UNITED STATES PATENT AND TRADEMARK OFFICE

APPLICATION NO.	FILING DATE	FIRST NAMED INVENTOR	ATTORNEY DOCKET NO.	CONFIRMATION NO.
09/804,287	03/12/2001	Timothy Kolody	MED 2 1118	7462

## Office Action Summary

## **DETAILED ACTION**

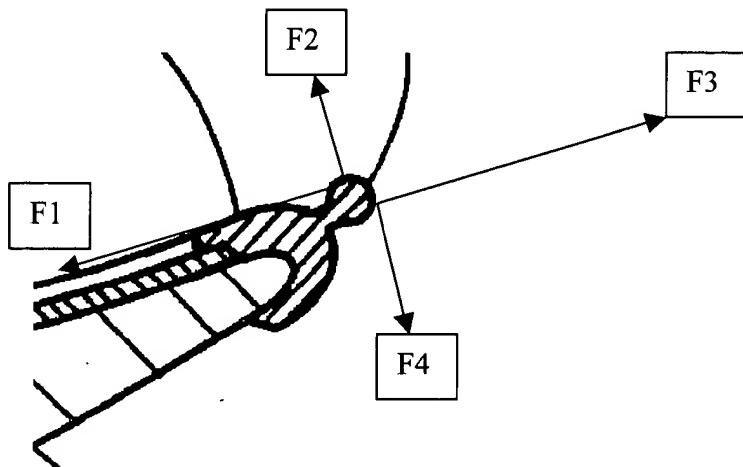
Claims 1, 2, and 6 are rejected under 35 U.S.C. 102(b) as being anticipated by Velazquez (USPN4484571).

As to claim 1, Velazquez discloses in a radiolucent patient support table (11) including substantially planar top and bottom surfaces (Webster's New World Dictionary defines "planar" as "a flat, level, or even surface", and defines "even" as "smooth"; thus the top and bottom surfaces disclosed by Velazquez are indeed planar) held apart in an opposed relationship, a

medical appliance support interface (fig. 7, 39, 41) for selectively connecting an associated medical appliance to the table, the interface comprising:

Velazquez discloses an interface (39, 41) having near 360 degree contact with the associated medical appliance, and thus has the supporting forces recited in the above claim.
